This is in response to your January 24 letter to Mr. Gerald L. Eller requesting Federal Highway Administration's (FHWA) acceptance of your double neck Pole-Safe breakaway support couplings for light poles, call boxes, and small sign posts. Transmitted with your letter were copies of two reports of pendulum testing conducted by Southwest Research Institute, static test reports from PSI/Pittsburgh Testing Laboratory, and drawings of the prototype and production couplings.

This is in response to your March 28 letter to Mr. Gerald L. Eller requesting the Federal Highway Administration's (FHWA) acceptance of your double neck Pole-Safe breakaway support couplings for light poles, call boxes, and small sign posts. Transmitted with your letter were copies of two reports of pendulum testing conducted by Southwest Research Institute, static test reports from Pittsburgh Testing Labs, and drawings of the couplings.

This is in response to your December 12, 1996, letter to Mr. Gerald L. Eller requesting Federal Highway Administration's (FHWA) acceptance of your double neck Pole-Safe breakaway support couplings for light poles, call boxes, and small sign posts. Transmitted with your letter were

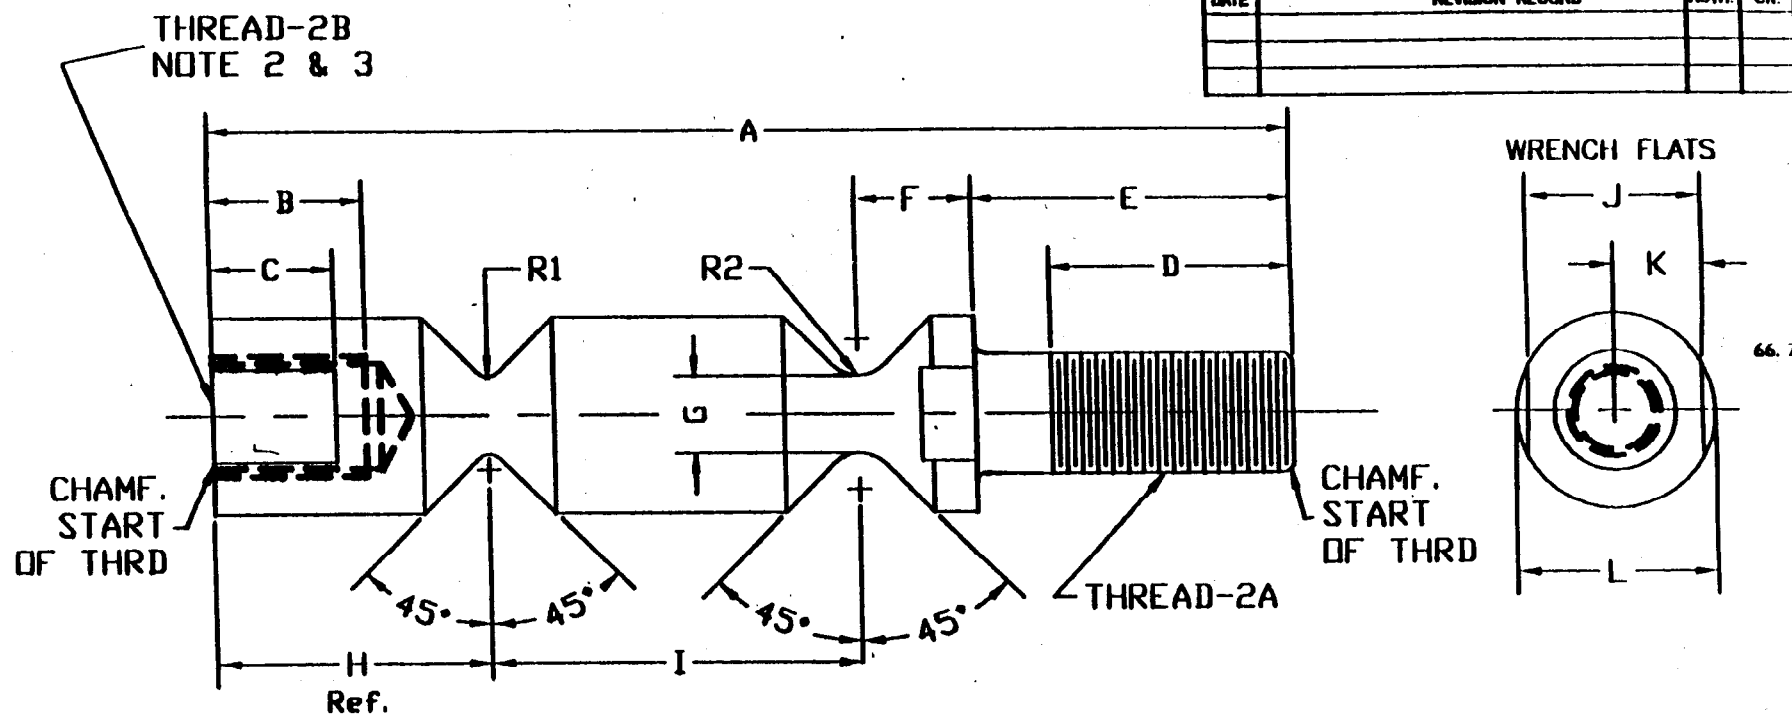
Drawings of the Series 4000 and 5000 Pole-Safe couplings are enclosed. The various coupling series and sizes are manufactured of proprietary "E.T.D. 150" steel. Dimensions and physical properties of the couplings are summarized in the following table:

*Couplings used in tests. Because the neck diameter of the largest of the three couplings in both the 4000 and 5000 series is the same as that of the tested coupling, similar performance can be expected.

The results of the tests meet the change-in-velocity and stub height criteria adopted by the FHWA. Therefore, Pole Safe Couplings Series 4000 and 5000, as noted in the table above, are acceptable for use on the National Highway System (NHS) within the range of conditions tested when requested by a State.
